ERRATA
West Lilac TM Environmental Impact Report
3100 5276 (TM); 3910 02-02-002 (ER)
State Clearinghouse No. 2006091067

Changes have been made to the Draft Environmental Impact Report (Draft EIR) in a tracked/change format. These changes are based upon comments received during the public review period as well as minor clean up items. The following changes are identified for the West Lilac Draft EIR.

Typical Bioretention Basin

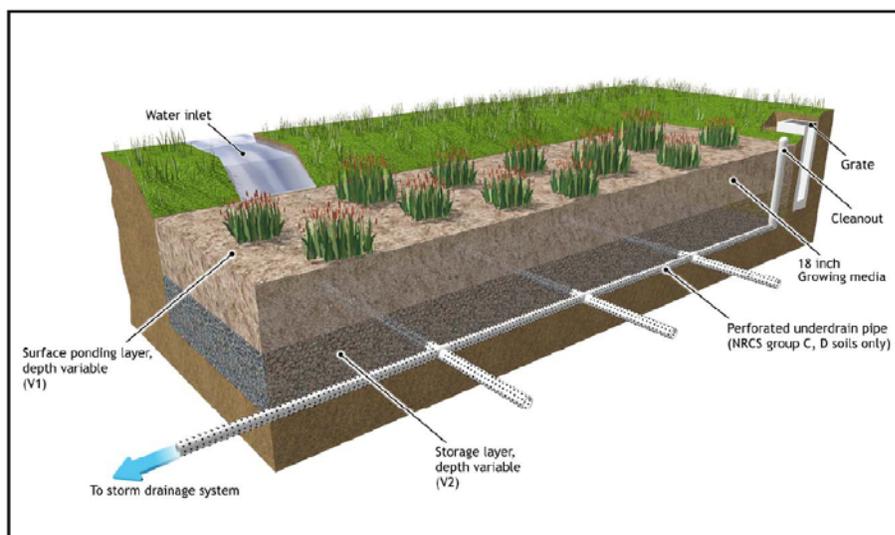
1. As a result of the analysis presented in the hydromodification study (EIR Appendix O), the project design features have been modified to include bioretention basins for the building pads and for the private roads¹. Each of the 28 building pads will contain two bioretention areas and an additional 15 bioretention basins are proposed for the private roads. These bio retention basins are depicted on Figure A and also Figure 3.1.5-1 of the EIR, attached to this Errata. The bioretention basins for the future homes will be within the footprint of the disturbance area for the buildings pads. This does not result in any new environmental impacts since the disturbed area will remain the same. The private road bioretention basins are proposed in depressed topographic areas that would receive stormwater runoff naturally. Construction of all bioretention basins would be done mechanically with the use of a bobcat (or similarly sized equipment). The bioretention basins would be excavated, as needed, and then layered with a storage layer, a growing medium layer, and then a surface ponding layer. Appropriate vegetation would be planted within the bioretention basins. Each of the bioretention areas will also have an overflow catchment for purposes of routing flows from larger storm events.

Approximately once per year, the bioretention basins will be inspected to verify that they are operating properly and to remove trash, dirt, and debris creating any blockage in the bioretention system. This periodic inspection and maintenance work will be done by an individual or individuals and will include hand-removal of trash, dirt, and debris blocking the bioretention basin. This periodic inspection and maintenance work will not result in any significant environmental impacts given its very limited time duration estimated at ten to fifteen minutes per basin and the limited work required for hand-removal of trash, dirt, and debris. A sample bioretention basin is depicted below.

Implementation of these bioretention basins will reduce potential off-site flow and erosion impacts when compared to the analysis contained in the Draft EIR. Since the bioretention basins are now proposed as part of the project, the EIR better discusses how the on-site flow will be retained and, therefore, the reduction of off-site flow and erosion impacts has been clarified in the EIR. With the bioretention basins proposed as part of the project, potential hydromodification impacts associated with the project clearly have been reduced to less than significant.

PRELIMINARY HYDROMODIFICATION PLAN

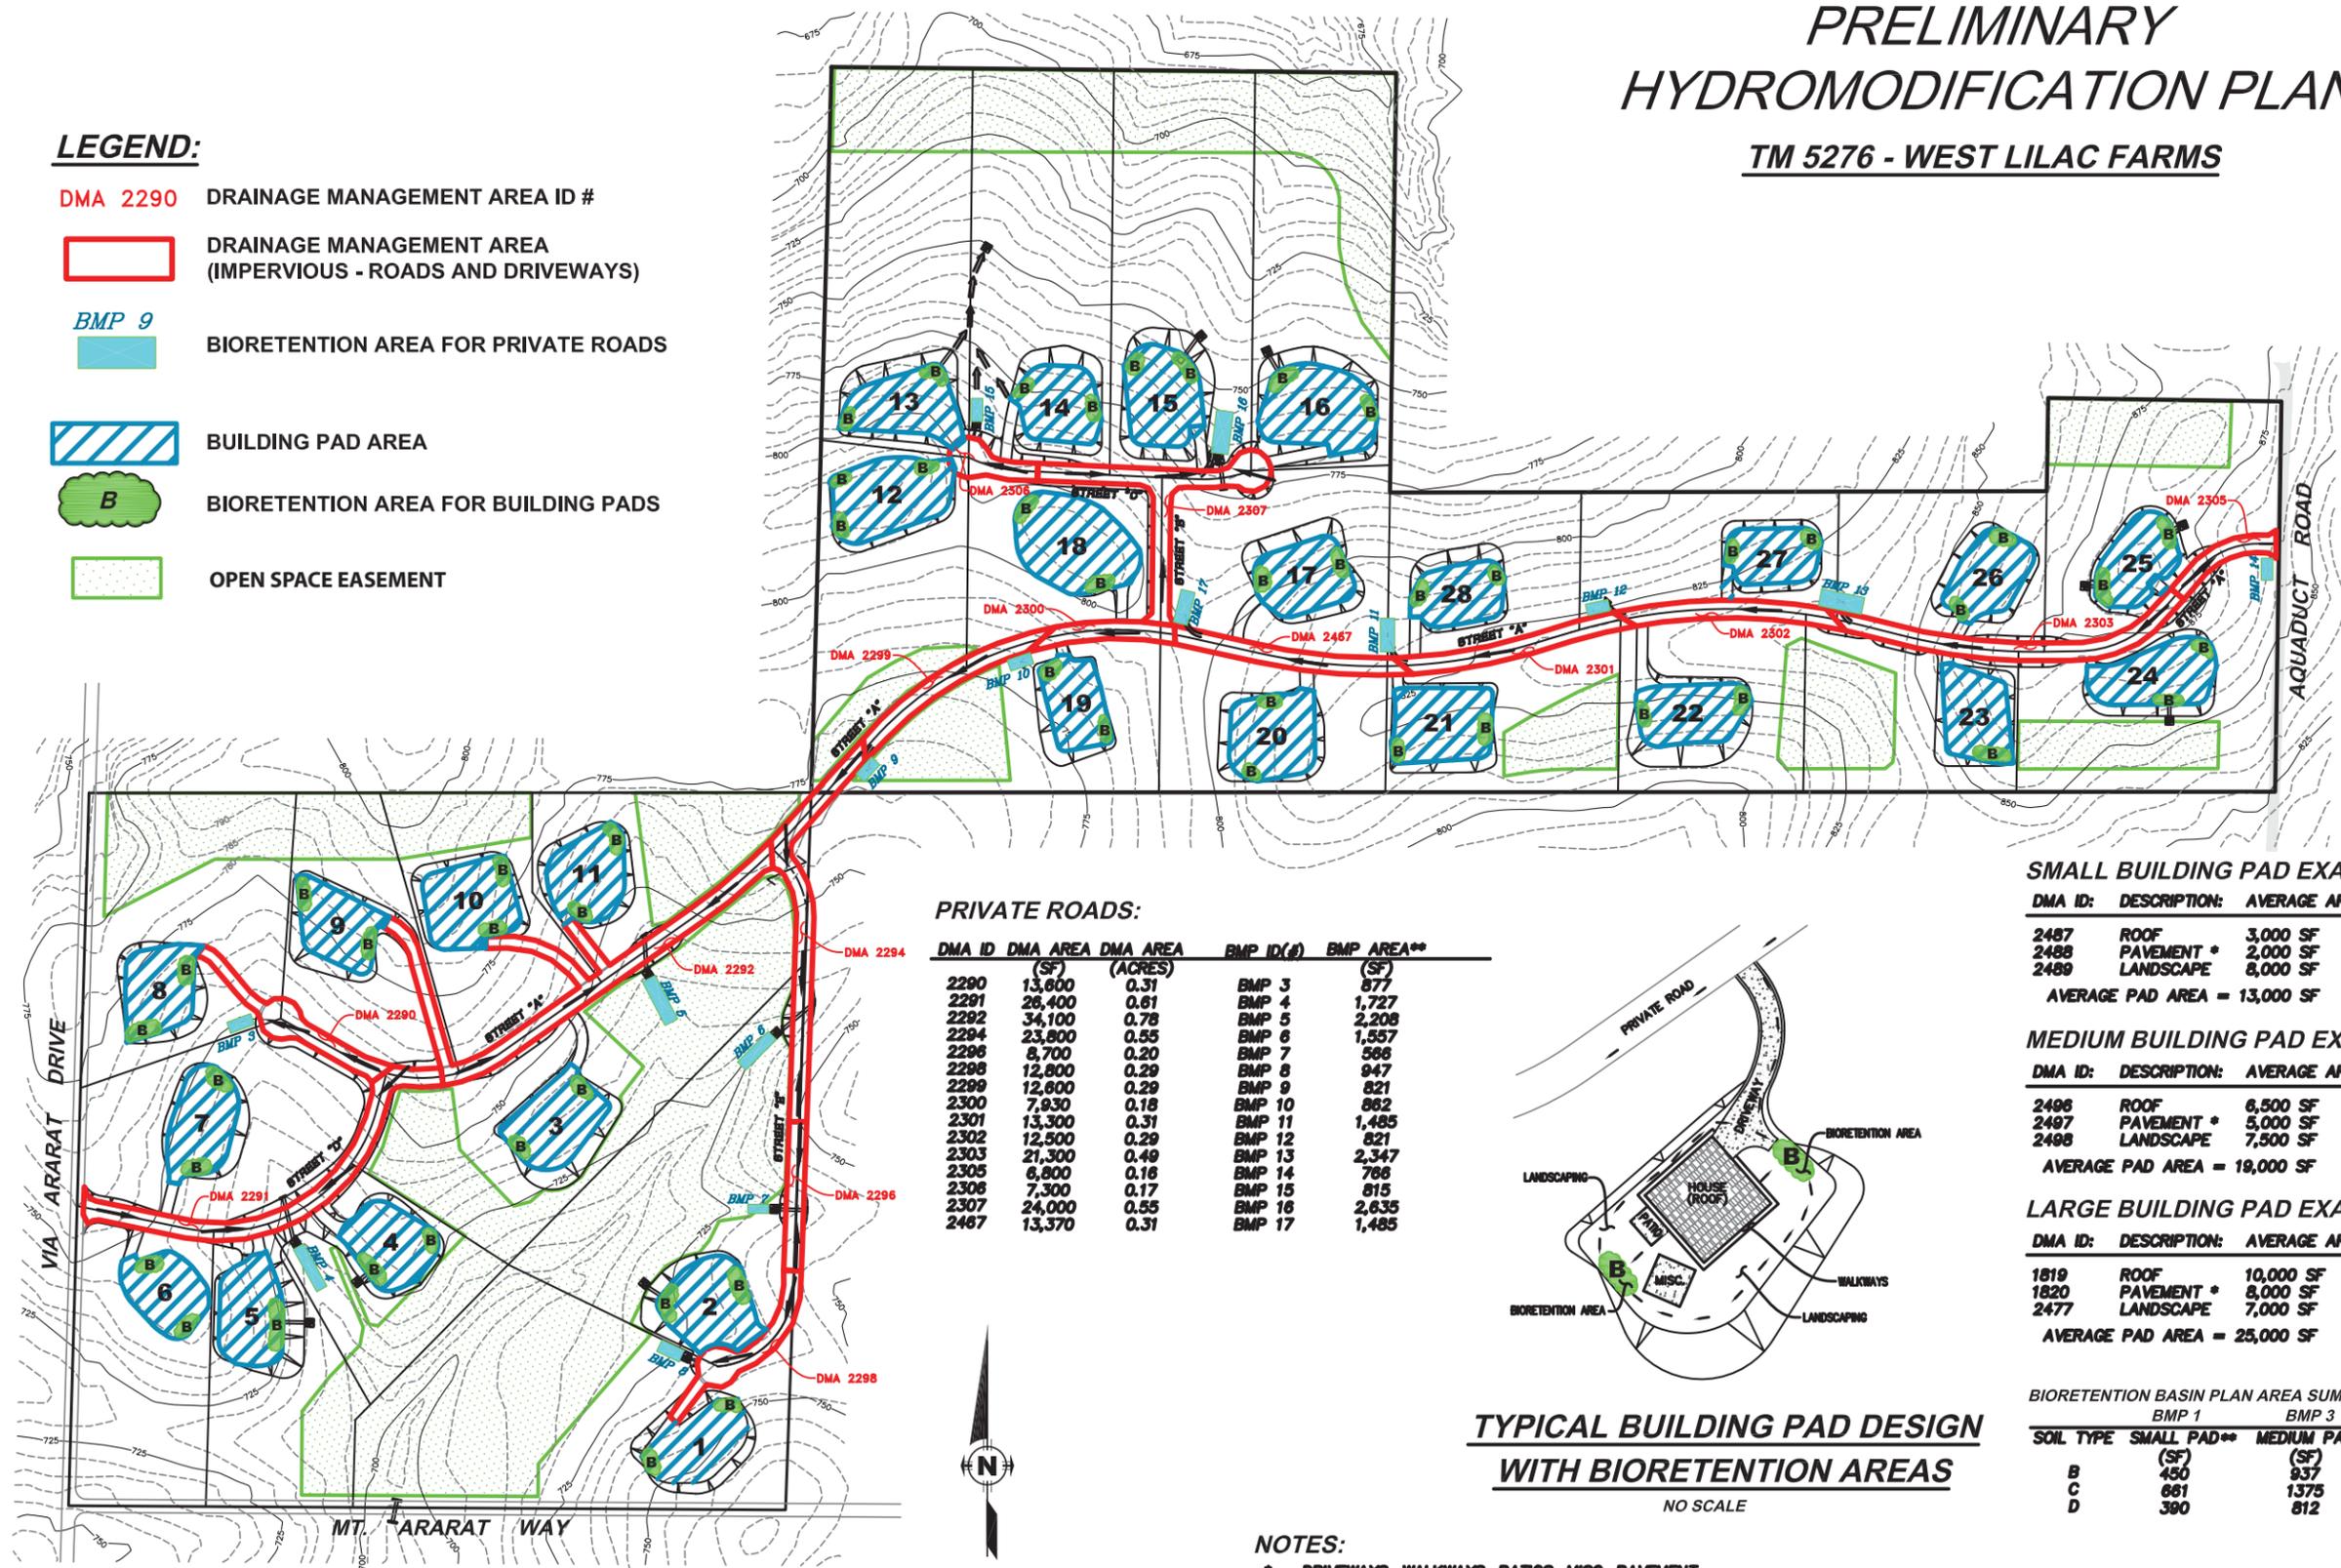
4. The following figures in the EIR, which depict the Agricultural Open Space Easement, shall now assume that the easement has been revised per Figures B1 and B2. These figures include:
 - Figure 1-1: Tentative Map (1 of 2)
 - Figure 1-2: Tentative Map (2 of 2)
 - Figure 1-3: Fuel Management (1 of 2)
 - Figure 1-4: Fuel Management (2 of 2)
 - Figure 1-5: Grading Plan (1 of 2)
 - Figure 1-6: Grading Plan (2 of 2)
 - Figure 2.2-1: Agricultural Impacts
 - Figure 3.1.3-1a: Biological Resources West Parcel
 - Figure 3.1.3-1b: Biological Resources East Parcel
 - Figure 3.1.8-1: Wells and Agriculture Exhibit
 - Figure 3.5-1: Preliminary Hydromodification Plan
 - Figure 4.3-1: Reduced Farmland Impact Alternative

**REVISED EASEMENT
FOR BMP FACILITIES**

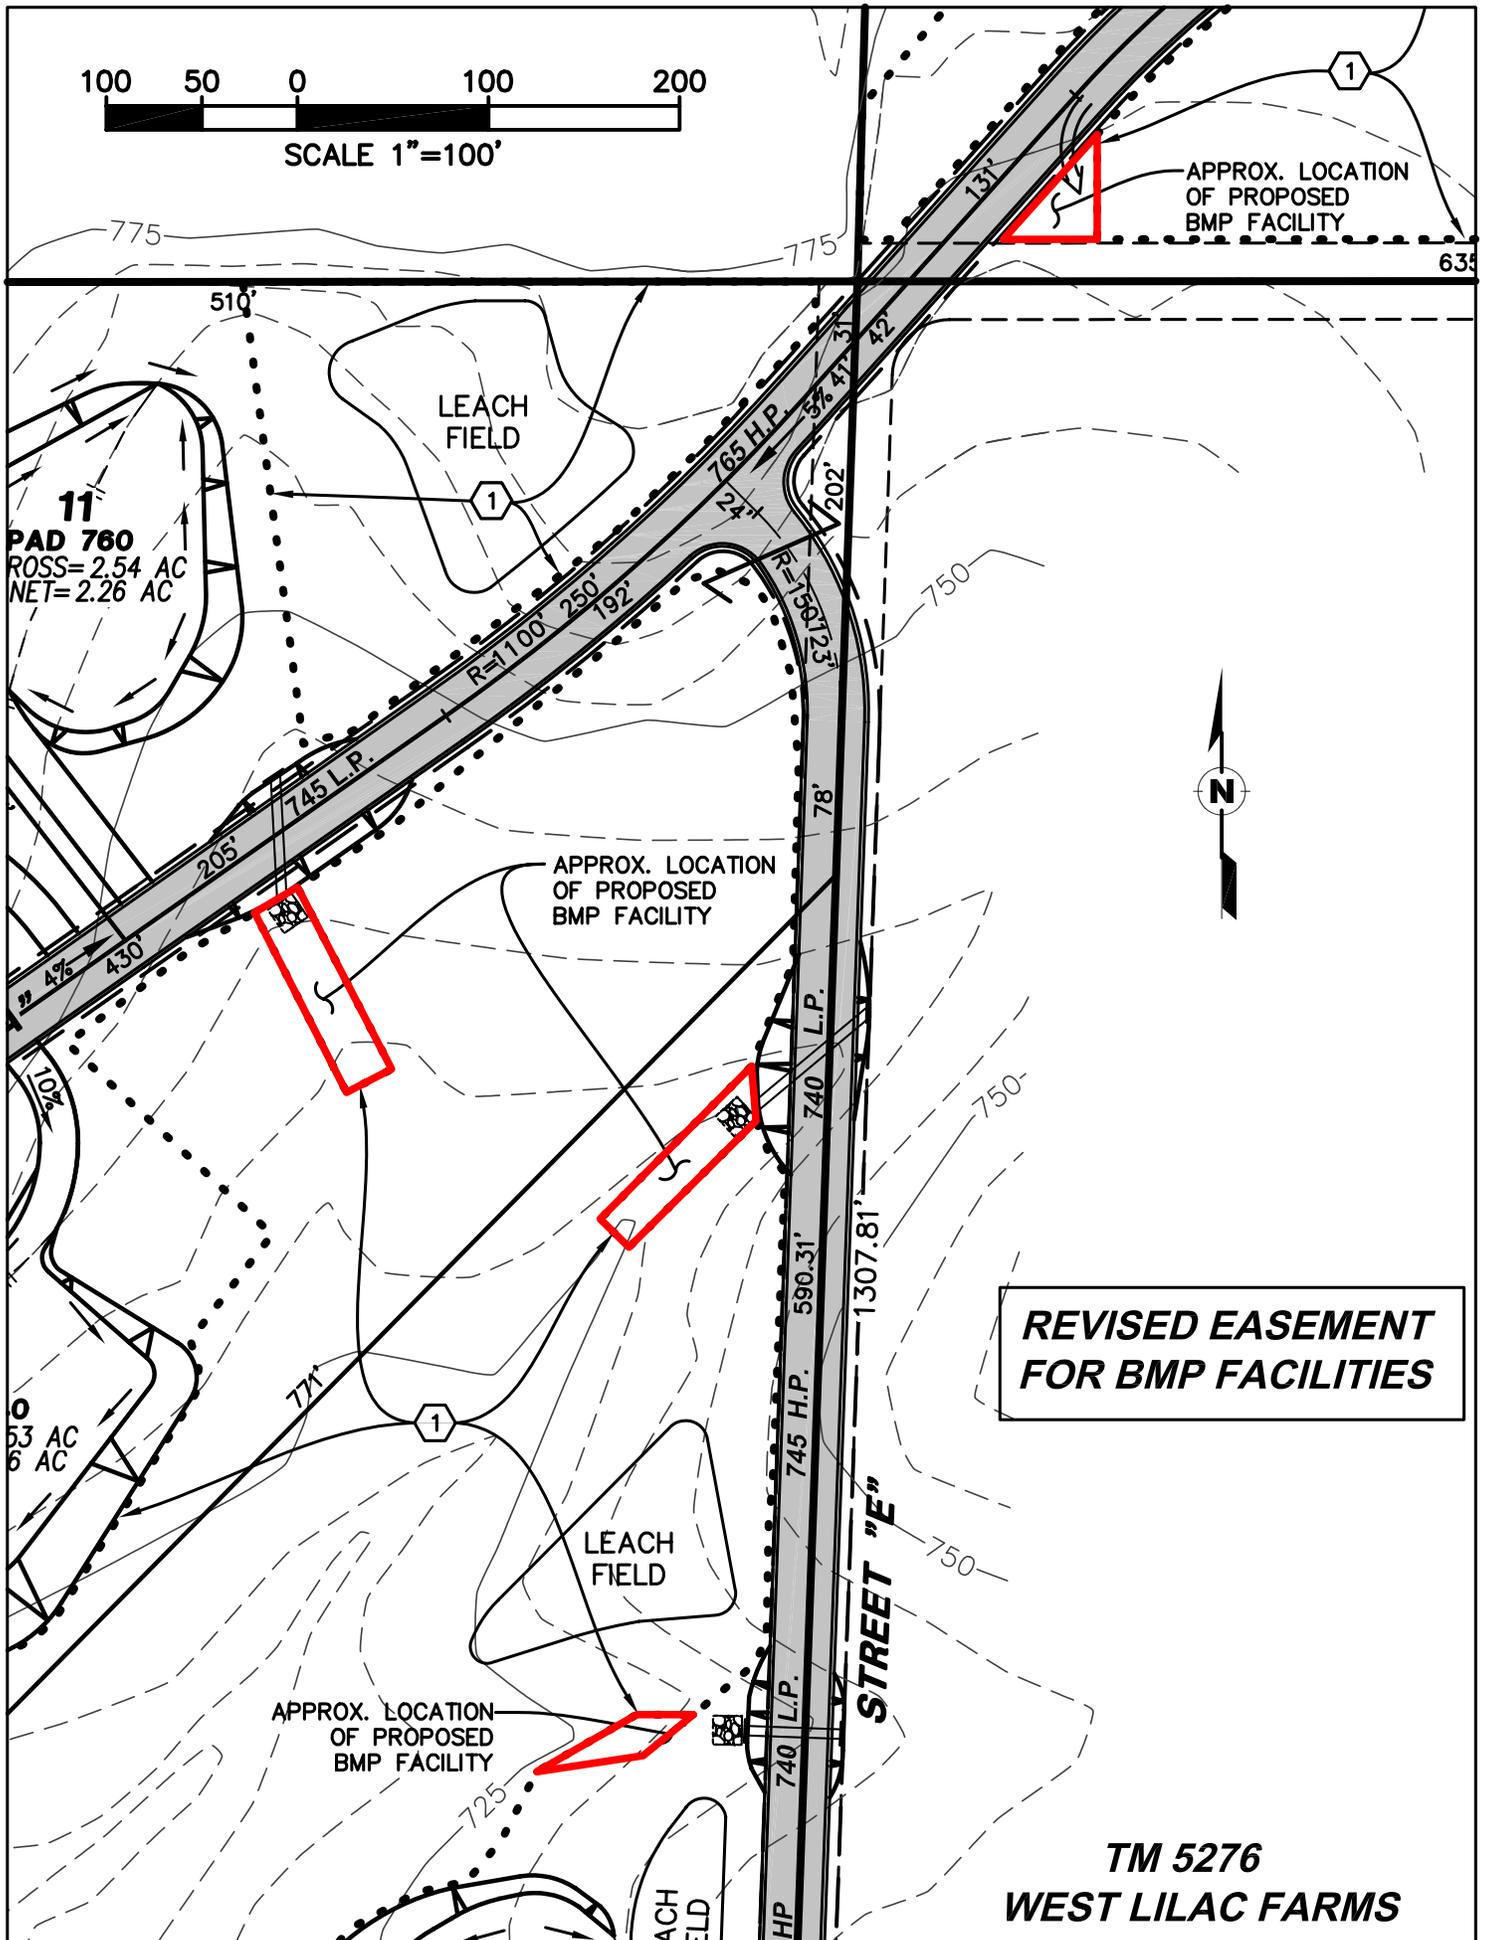
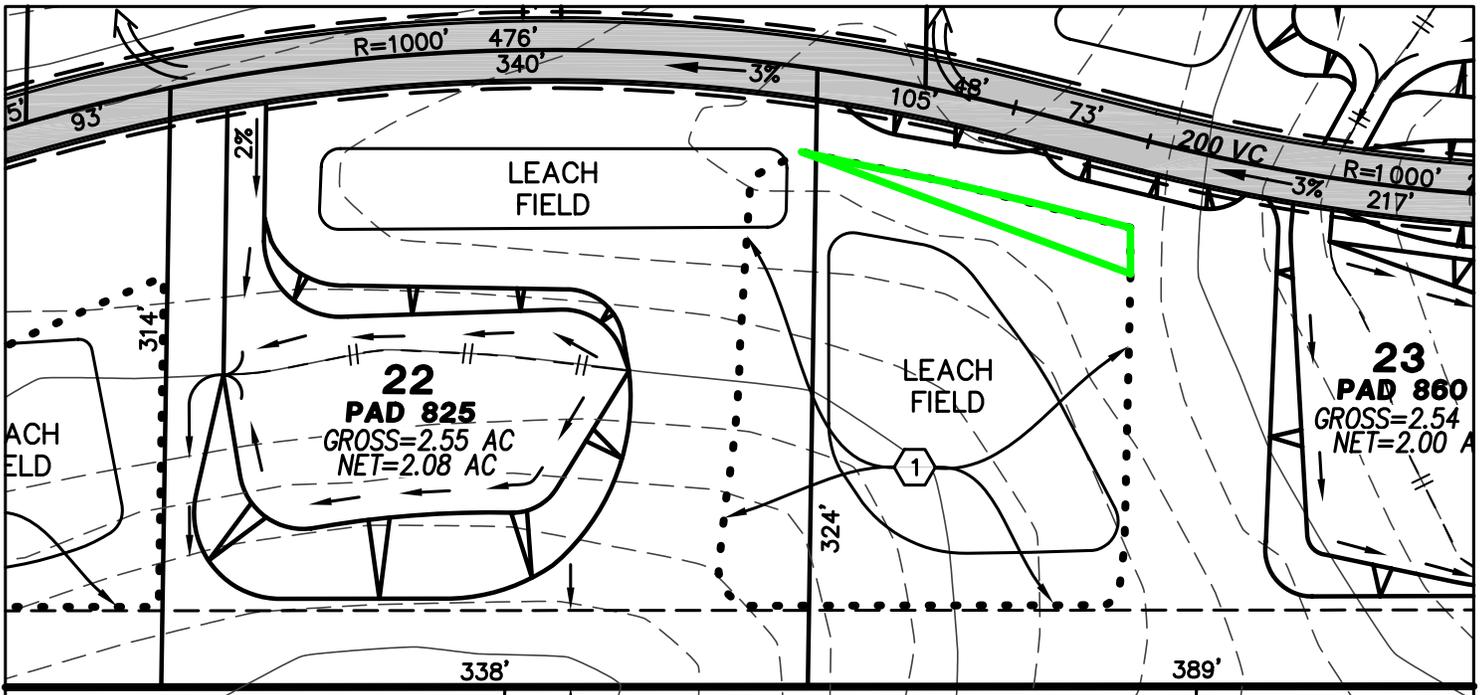
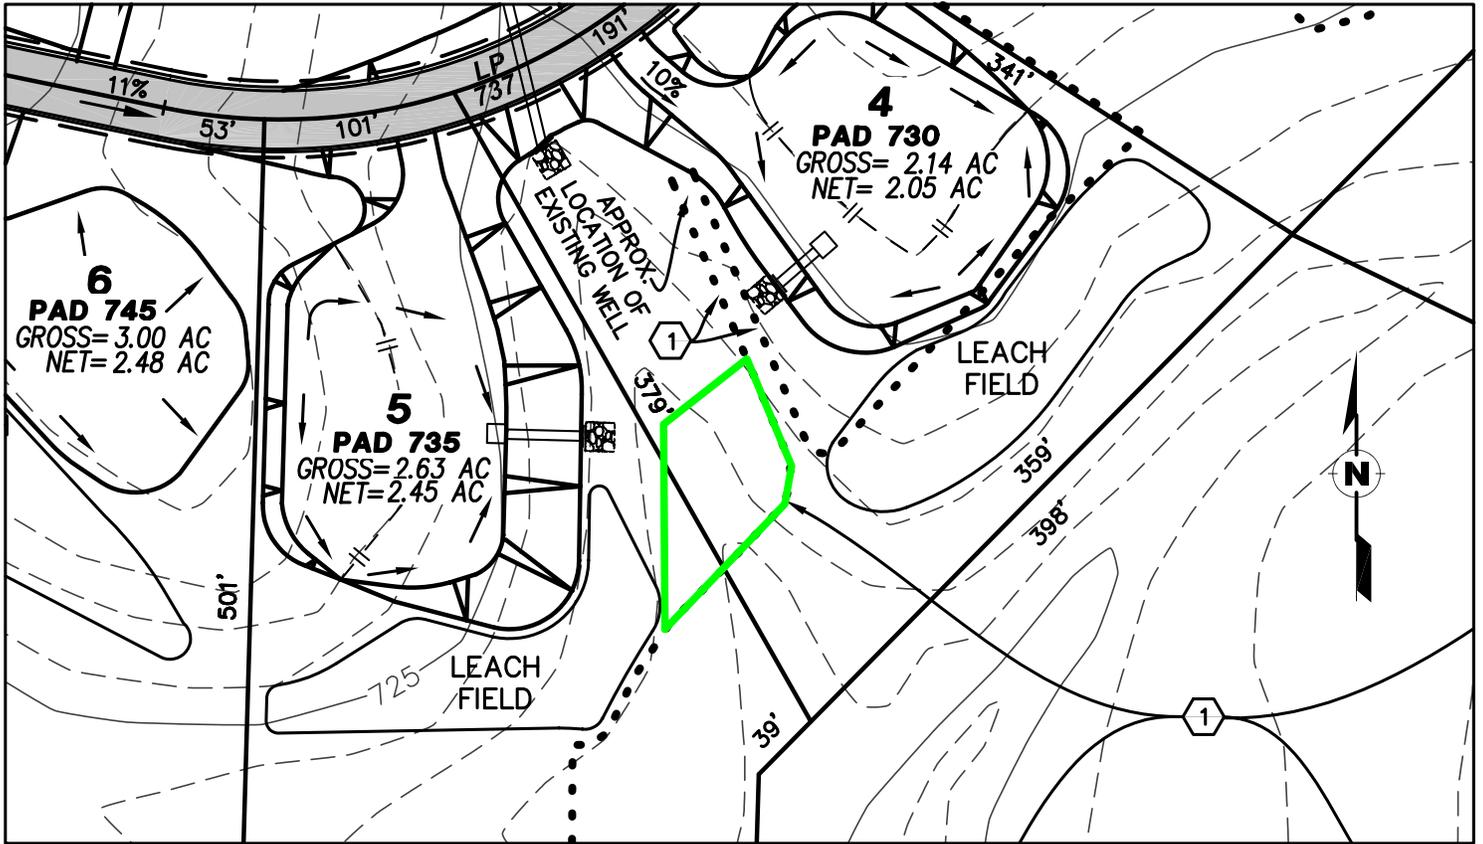
2. Due to existing topography and the preference to have the bioretention facilities in topographic swales, some of the bioretention facilities for the private roads would need to be placed within the Agricultural Open Space Easement; specifically BMPs 5, 6, 9 and a portion of 7. In order to avoid a conflict between these bioretention areas and the Agricultural Open Space Easement, the Agricultural Open Space Easement has been modified, as noted on Figures B1 and B2, attached to this Errata. Areas in red shown on Figures B1 and B2 represent areas where the Agricultural Open Space Easement will be reduced (approximately 0.17 acre) and areas in green represent areas where the Agricultural Open Space Easement will be increased (approximately 0.17 acre). From an acreage perspective, the adjustments are the same size, thus the proposed Agricultural Open Space Easement will still be 22.6 acres. The revised agricultural open space easement also includes the same amount of PeC soils as shown in the Draft EIR. This results in no change to the 22.6 acre agricultural preserve area or the amount of Placentia sandy loam (PeC) soils included in the Agricultural Easement Area.

bioretention basins consist of soil and vegetation, the basins will allow for continual agricultural production on the PeC soils within the bioretention basins. As a result of minor adjustments to the Agricultural Open Space Easement, both the 22.6 acre agricultural preserve area and the 13.8 acres of PeC soils within this preserve will remain the same as described in the Draft EIR. The bioretention basins do not result in any new impacts to PeC soils and the agricultural mitigation proposed in the Draft EIR remains the same fully mitigating all agricultural impacts of the project to a level of insignificance.

The conditions of the Tentative Map include a requirement to adjust the boundaries of the easement accordingly.
